Product hierarchy no. *				Part no.	SBU	Type / Description	Customer part no.
SBU	PG	PUG	Type				
02	005	116	0000001167	See list below	Power Entry modules 10A	DC21

2 Type of change

Product Change Notification					PCN DC21		
owner	creation date	release date	released by	change order no	rev	page	D10-013-559
hotzar	2017-02-01	2017-02-16	buerglal	2012095	A	1 of 2

Old label	New label

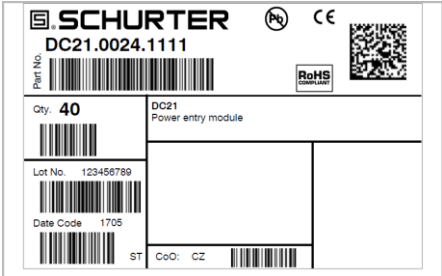
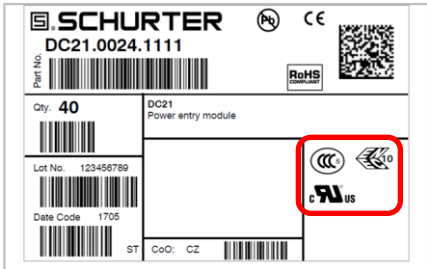
- Change of markings
- Modified packing label

- Product has new CCC approval.

Old approval marks on product	New approval marks on product

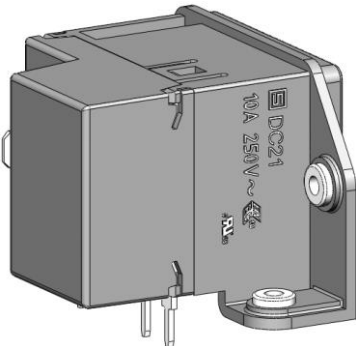
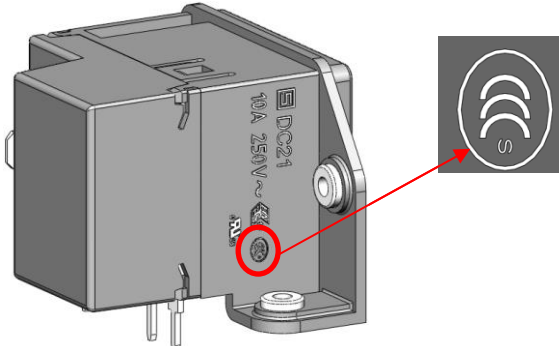
Form	Yes	New CCC approval mark
Fit	No	No change for dimension
Function	No	No change in function
Manufacturing	No	No change for manufacturing site
Label	Yes	New with approval marks
Packaging	No	No change in packaging
